# APPLICATION FOR BUILDING CONSENT

BC  
126108.

Provide a full description of the building work:  <i>E.g. 4-bedroom dwelling with multiple cladding types and attached garage</i>	Construct a new 4 bedroom single level dwelling with attached double garage. RCS insulated facade cladding & Linea cladding over cavity systems. Corrugated roofing systems. Tiled wet shower areas. Water tank storage and waste water systems
-----------------------------------------------------------------------------------------------------------------------------------------	-------------------------------------------------------------------------------------------------------------------------------------------------------------------------------------------------------------------------------------------------

**Designed by**  
Version BC01 RFI  
Scale: 1:100  
Page A8 RFI

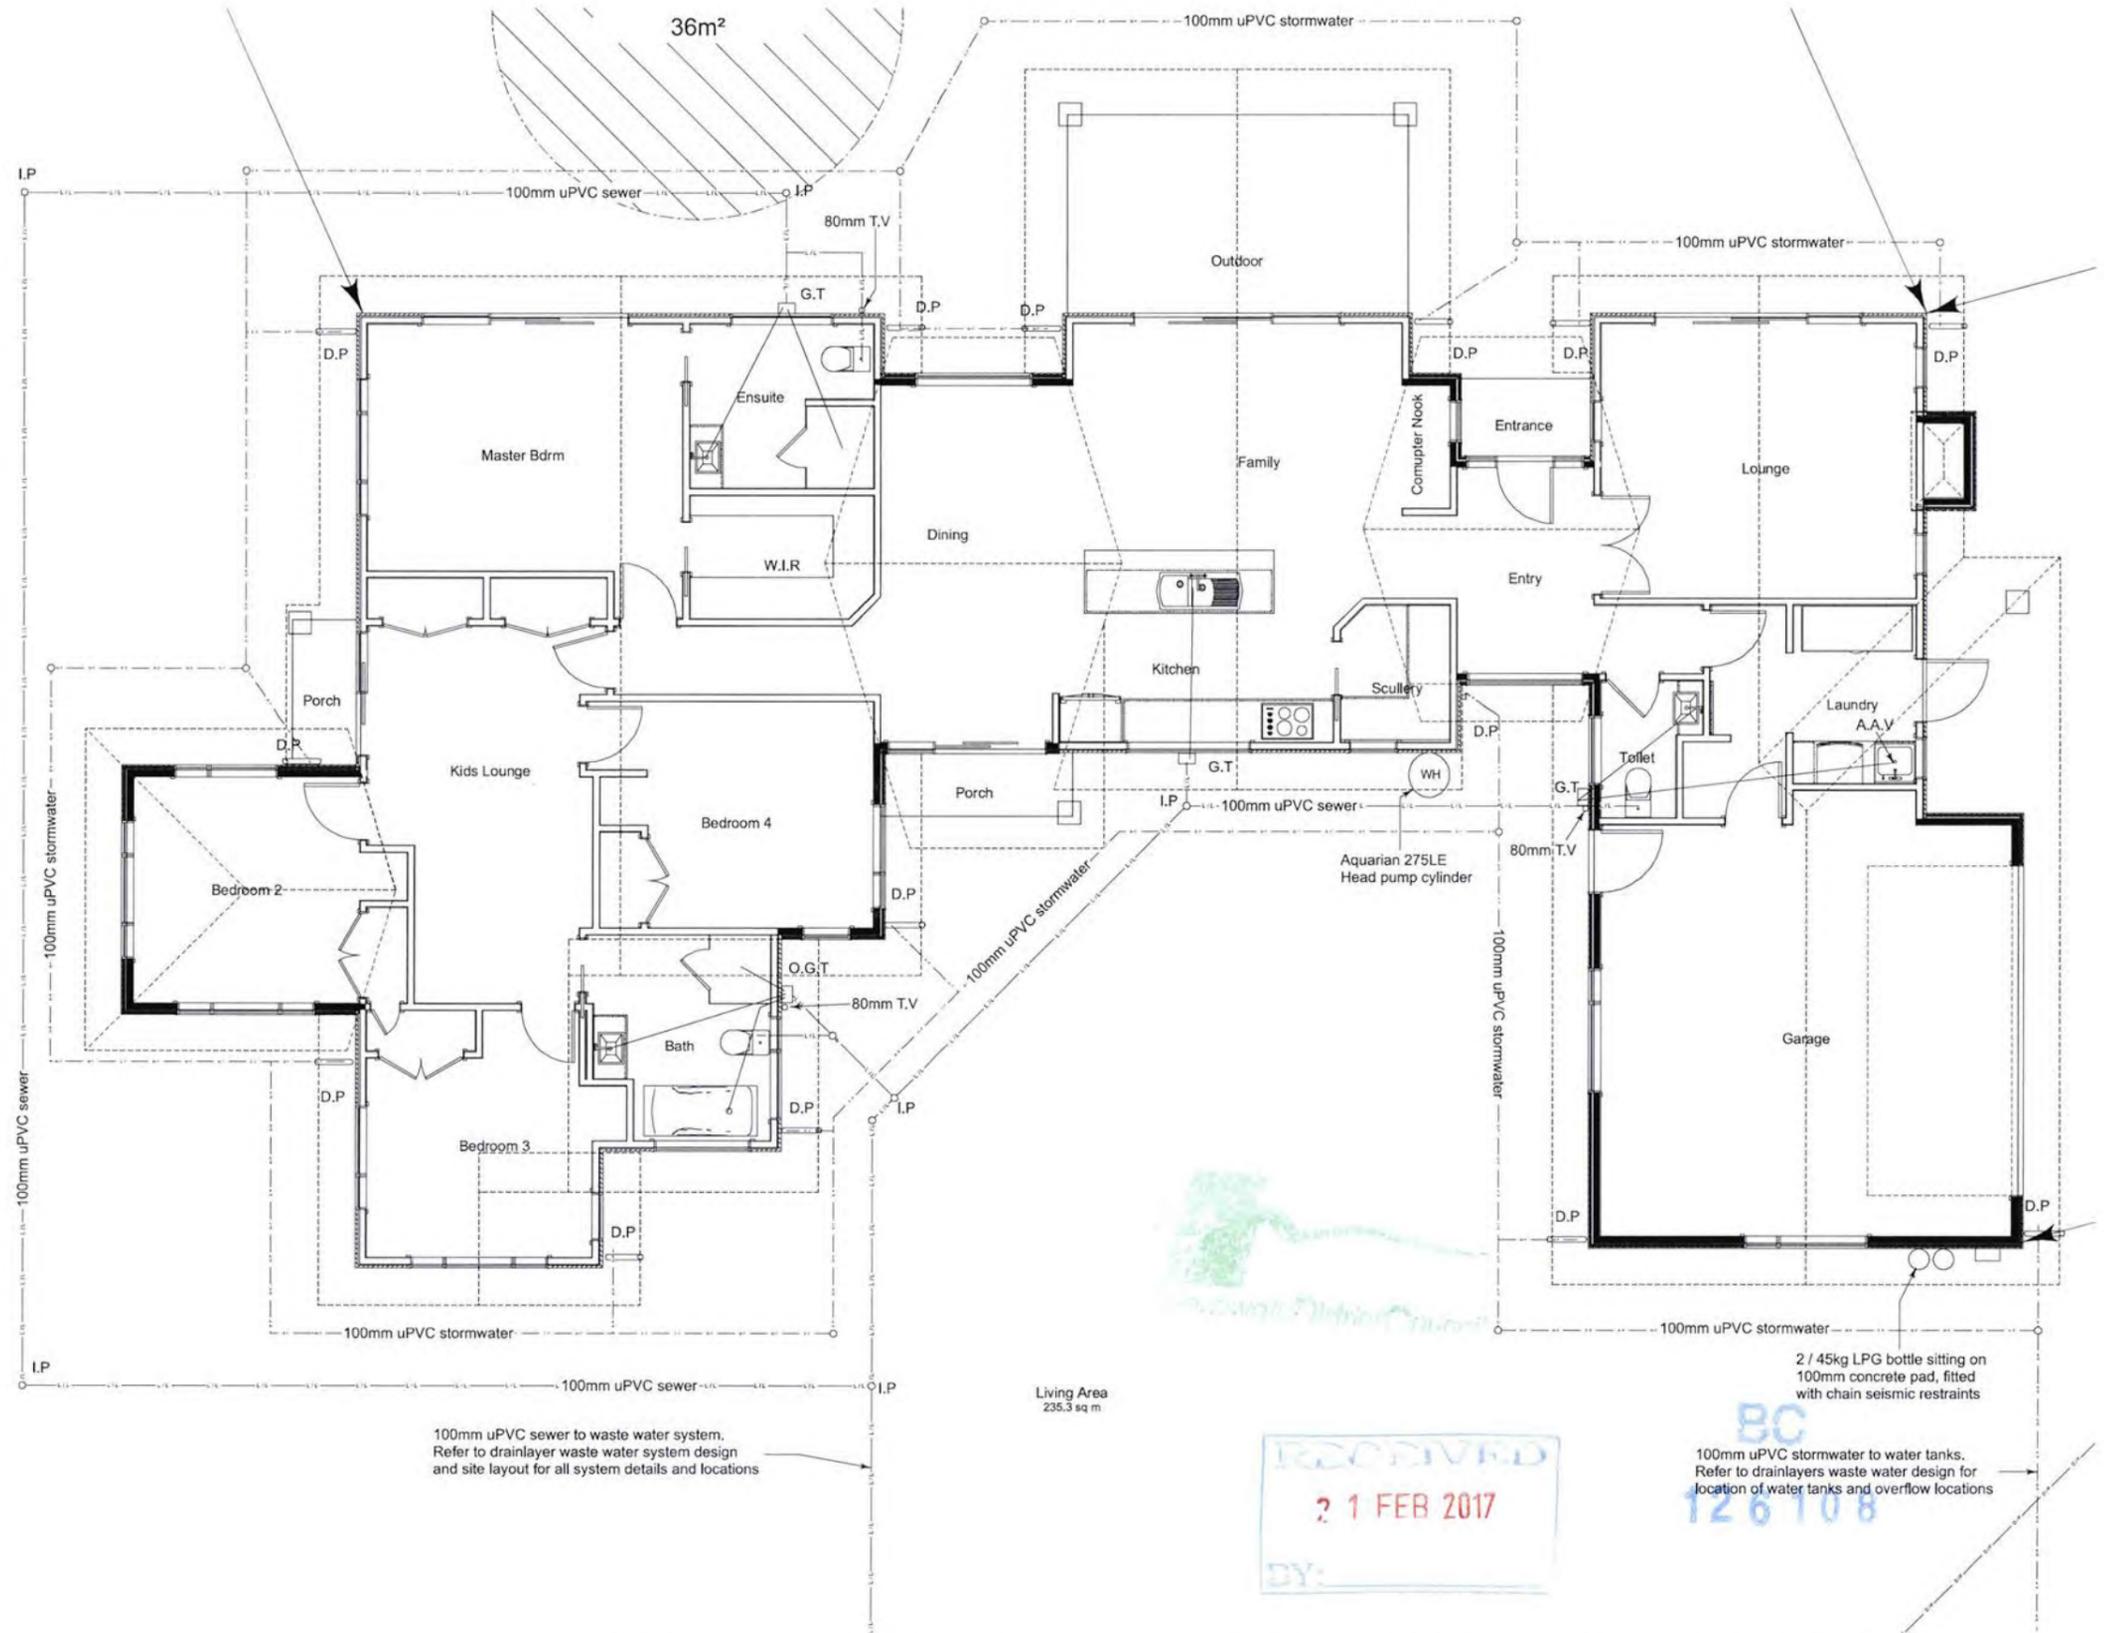
Revision Table			
Number	Label	Date	Description
1	R1	19/01/17	Heatpump Cylinder
2	RFI	18/02/17	Compliance changed to G13/AS1
